Proposed Modifications to IEEE P802.3az/D0.9 Clause 40

**Adam Healey, Niall Fitzgerald,
Jacobco Riesco, Brian Murray
LSI Corporation**

**IEEE P802.3az Task Force Meeting
Seoul, KR
September 2008**

Motivation: Wake from Refresh

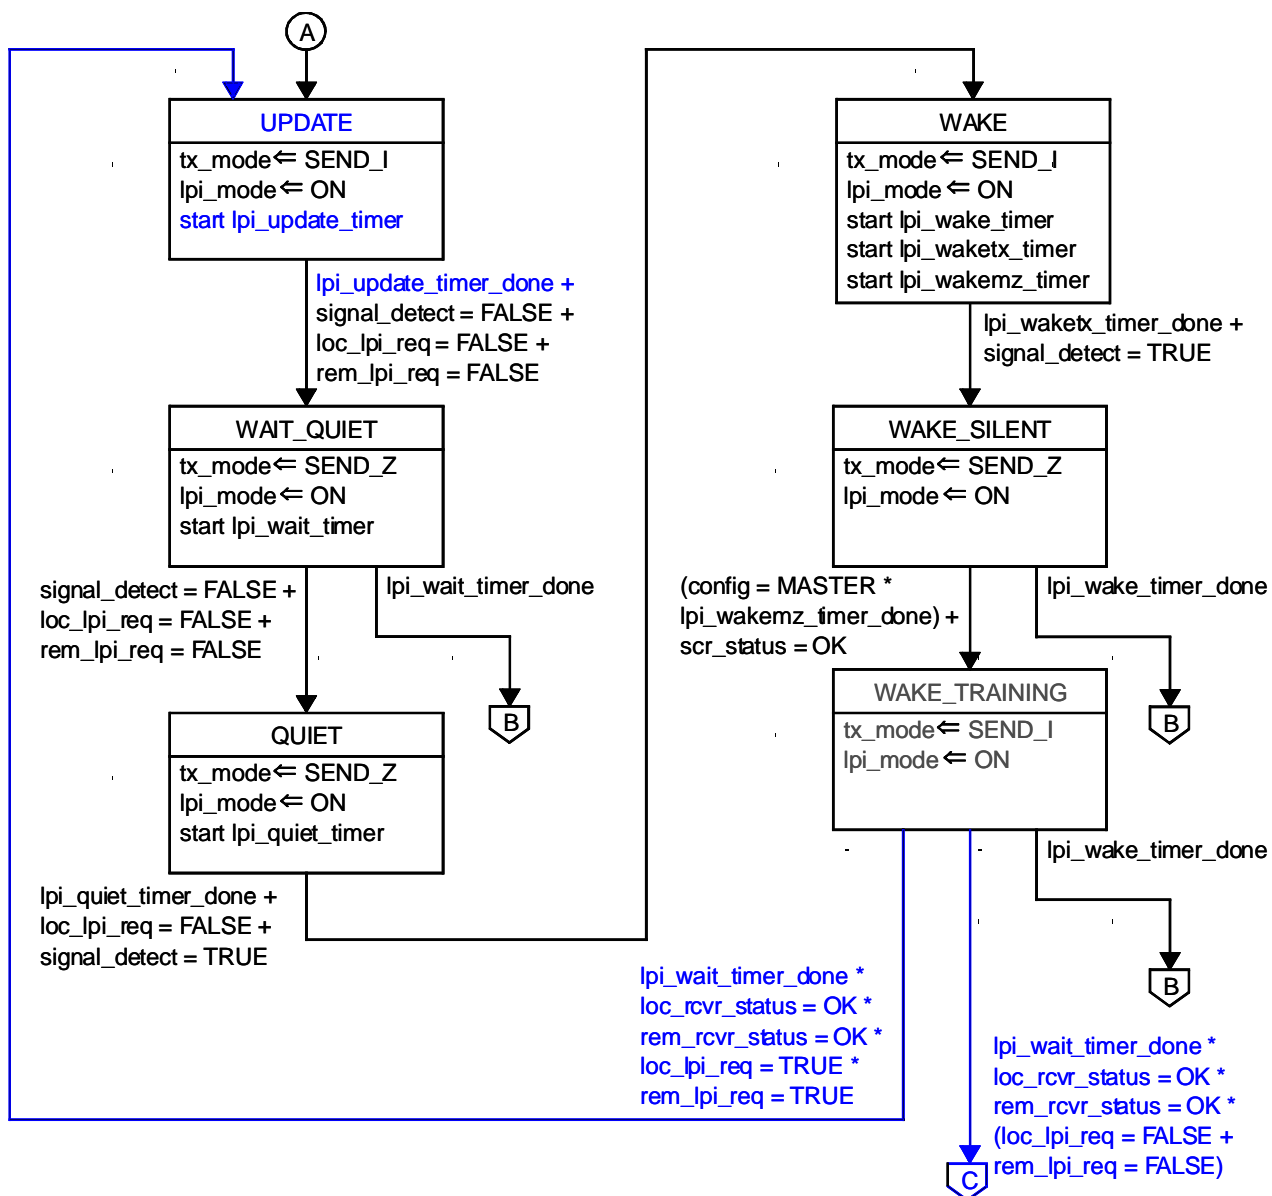
- It has been pointed out* that, per the current PHY Control state diagram, there is a possibility that the local device could receive zero during SEND_IDLE_OR_DATA when the local device de-asserts loc_lpi_req during UPDATE but the link partner transitions to WAIT_QUIET prior to receiving the notification
- Under certain timing conditions, the duration of zero could be on the order of the round-trip delay, leading to a link restart
- Also, it has been pointed out that the roles of SLEEP and UPDATE are similar so they may be consolidated into a single state
- This is reinforced by the fact that lpi_sleep_timer has recently been assigned a range similar to lpi_update_timer

- Consolidate SLEEP and UPDATE states
- Transition back to SEND_IDLE_OR_DATA from WAKE_TRAINING rather than UPDATE
- Refinement of transition conditions

- **40.4.2.4:** Upon activation of the low power mode, the PHY Control asserts `tx_mode = SEND_I` for period of time defined by ~~`lpi_sleep_timer`~~`lpi_update_timer` which allows the remote PHY to prepare for the transition to the `WAIT_QUIET` state. When ~~`lpi_sleep_timer`~~`lpi_update_timer` expires, PHY Control asserts `tx_mode = SEND_Z` and transmission ceases.
- **40.4.5.2:** Delete `lpi_sleep_timer`
